SMP Coastal Panel Meeting 12: Draft Coastal Adaptation Plans

Review and sign-off of draft Coastal Adaptation Plans for submission to the SMP Committee of Council and public consultation.

PU74 - Whangapoua Beach Estuary (which has a proper river name)

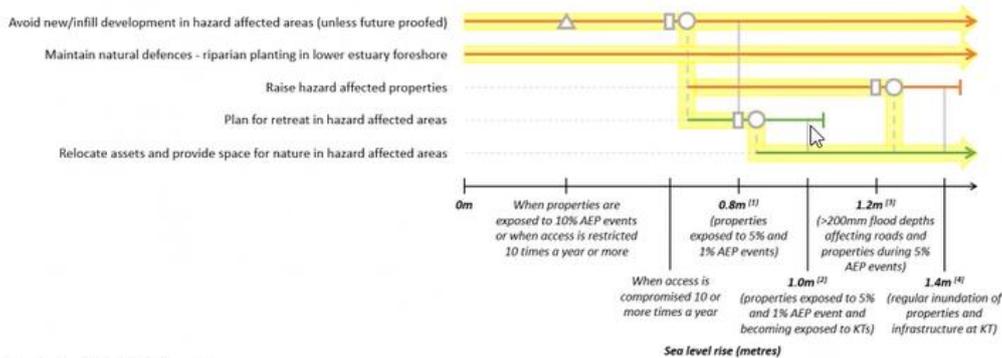
SJ – no significant effects on property until significant SLR, but the road is going to be affected much earlier – cutting off access. 0.2m SLR will affect access. Pathway does not include ‘raising the road’ when issues with access are acknowledged. JP – road is the back road and goes to Denise household, potential access to New Chums development. SJ – suggestion is to add action to raise the road and associated infrastructure and link in trigger.

75 - Whangapoua Beach

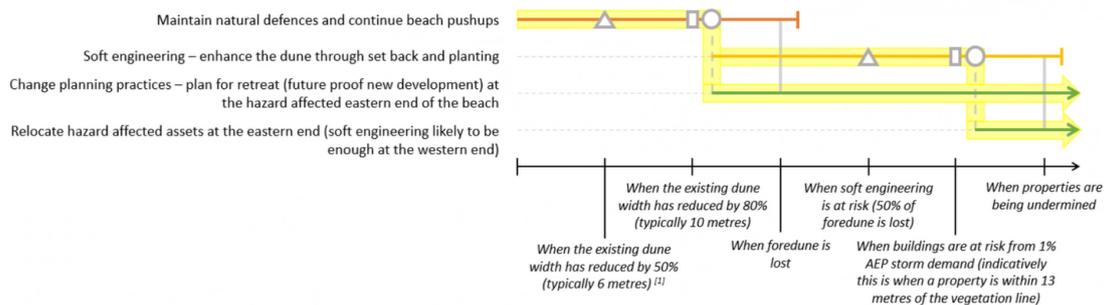
JP – questioned what is occurring regarding the sewage treatment plant

RL – when talking about hard defences, what happens in the scenario where a property owner builds a hard backstop wall on their own property to protect the property from storm cut events

AM – the wording ‘to maintain the natural beach in the long term’ should be considered when the proposals come forward – should be part of the consenting process.

JR – its there anything about the longevity of the solutions? Not in the language of the strategy narrative

SJ – it is included in PU78

SJ – will cover this in the SMP Plans

GO – feels there is enough freeboard in the narrative to cover any concerns re detail

AM – reflected in the pathways

PU80 - Matarangi Beach (East)

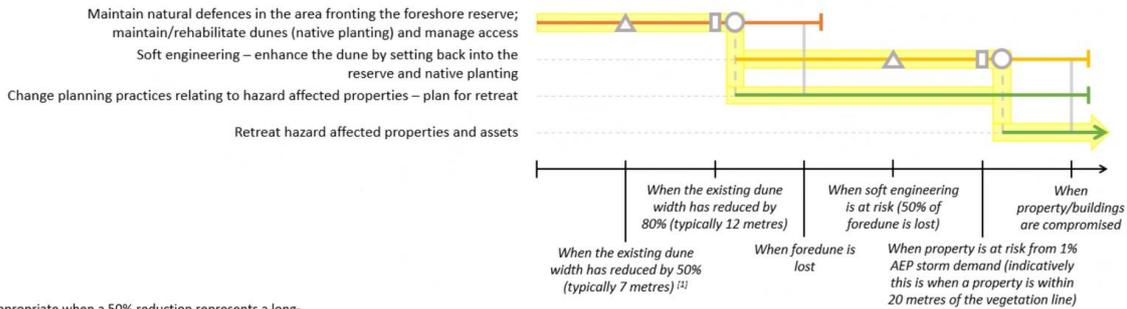
The trigger of 1%AEP storm demand will be changed to a signal rather than a trigger – a 20%AEP may be a more appropriate trigger?

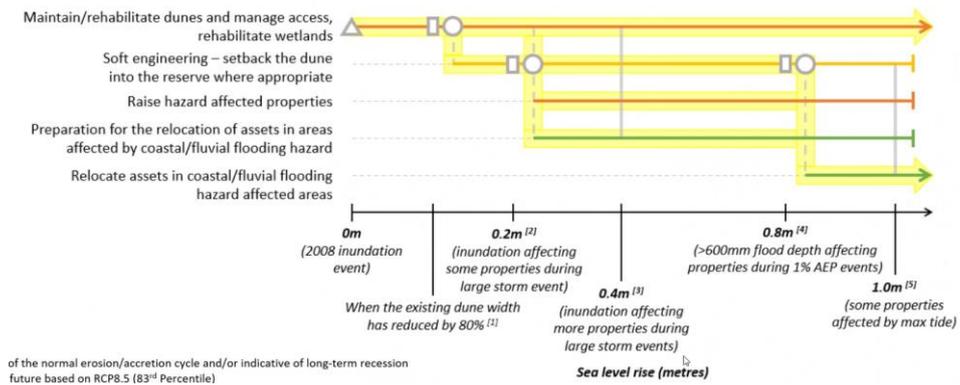
CP – there is a point at which the road is low, but we don't have raise the road in this pathway – of greater concern is the erosion of the road.

DL – thought we discussed strategy about the road last time – are houses to the west going to look at another way of access?

CP/DL – no option for developing a new access.

SJ – covered in previous policy with enhancement to rock wall

SJ – road may be regularly washed over – will add note that road may need to be looked at Discussion on how far out for the SLR should be shown. Some feel 100 years is too far out and should be 50 yrs

PU95 – Wharekaho

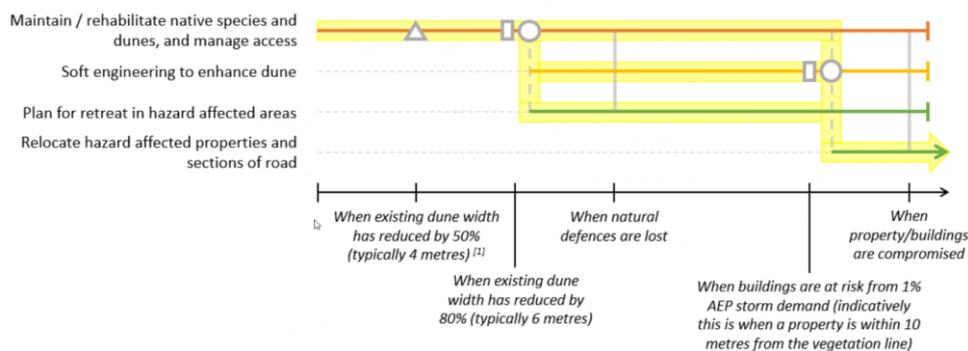
GO – many people prefer non – native (exotic) dune plants species. Suggest consistent use / reference to native dune species in both the pathway and in the strategy.

SJ – add in ‘routine and prompt clearing stream mouths’ (should apply to Kūaotunu stream too)

DL – southern end is a culturally sensitive area.

The beach will be compromised if rocks are put there – people went to this location specifically for the beach

South:

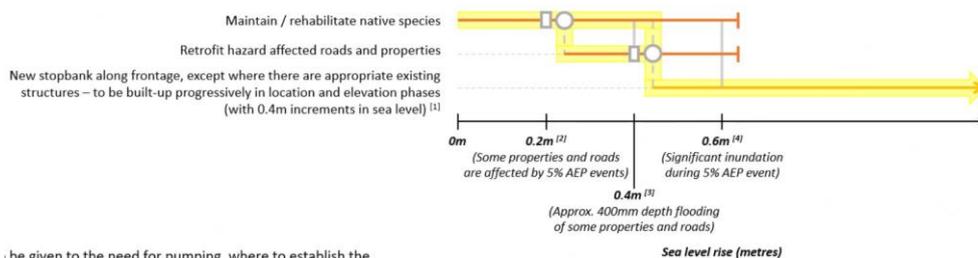
SJ – other PU's for Buffalo Beach signal was 0.4 not 0.2m – should they be consistent? After discussion, it appears that it is correct for the southern end
AM – 0.4m is probably a threshold, 0.2m should be a signal to make a decision

PU103 - Front Beach/Flaxmill Bay

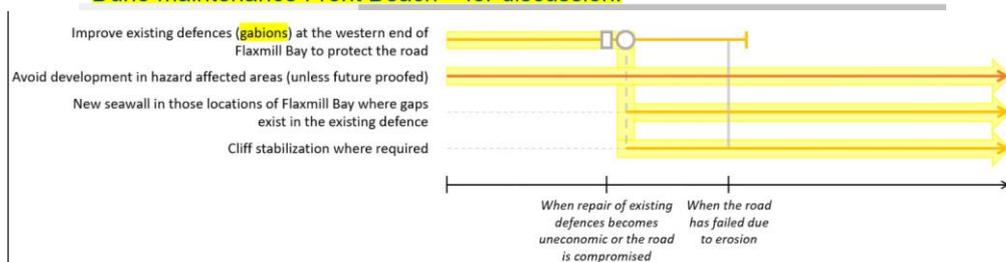
Dune maintenance Front Beach – for discussion.

SJ – this only applies to Flaxmill Bay, not Front Beach. Should we be talking about dune maintenance for Front Beach

JR – western side of Front Beach is quite low, as you go east it steadily climbs. A piece of road on the west side is right by the cliff and would need to be protected. (Gabions or a new defence). Suggests short term it is better to maintain the dune area.

SJ – need to include a strategy for Front Beach (may include potential retreat for perhaps 3 properties)

PU106 - Cooks Beach

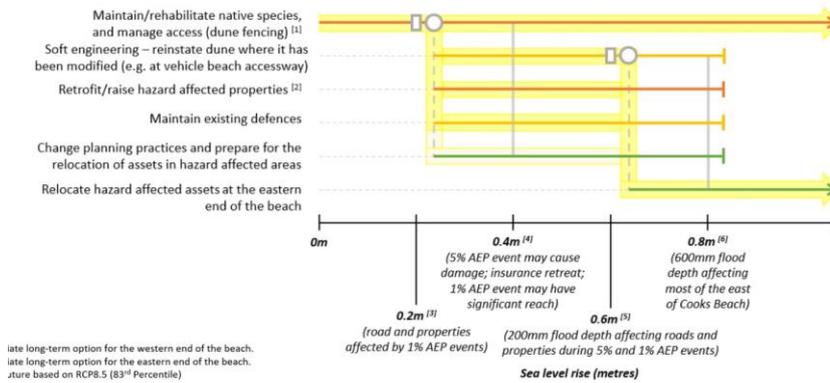
Comment made later was should the rock wall not be removed. (private homeowners wall – check how long this is consented for?)

JH – should beach push-ups be added? JB – these are more for maintenance rather than protection.

JR – thinks removing that wall is wise

SJ – could advocate for the wall consent not being renewed.

PU110 – Hahei

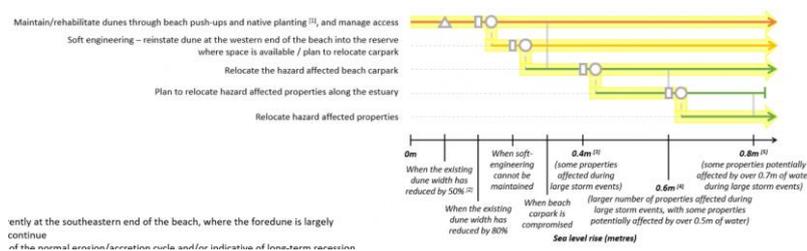
SJ – in most other areas we suggest ‘raise properties’ prior to suggesting retreat – do we need to add this step?

Agreement on adding this option

90 – Otama

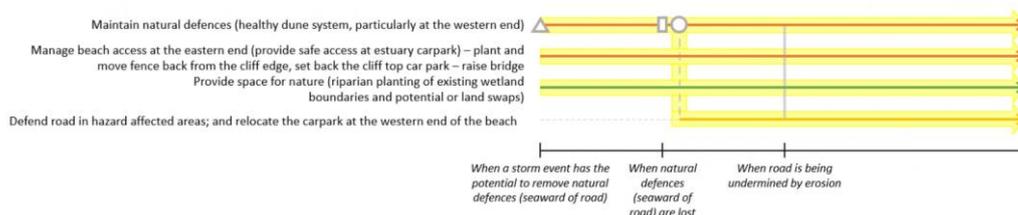
CP – no where to relocate the carpark to. One house may need to consider retreat.
Road is an issue as in a part comes right up to the coast.

GO queried the location of the house in question and suggested it was safe from SLR ... this needs to be confirmed?

DL – how often is the bridge flooded? What would the trigger be for it being raised?

JP – planned subdivision at the eastern end. Do we need mention of provision of the dwellings which will go in there which may be prone to inundation?

JP – can we put something in about avoiding inappropriate development in this area?

CP - Currently 1-2 x year.

DL – confirmed no subdivision application lodged for that land. Need to take into account floor levels etc now

Change wording to 'transport access' to capture road and bridge

PU112 – Hot Water Beach

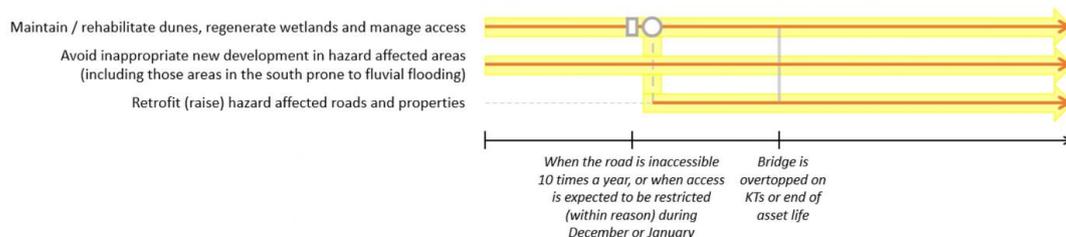
HS – is there data for Dalmeny Corner as that is where the main issues are?

Tolerance of disruptive events is too high (1 x month)

Engage with the business owners/community in the area

SJ – trigger needs further investigation (take out tourist peak reference)
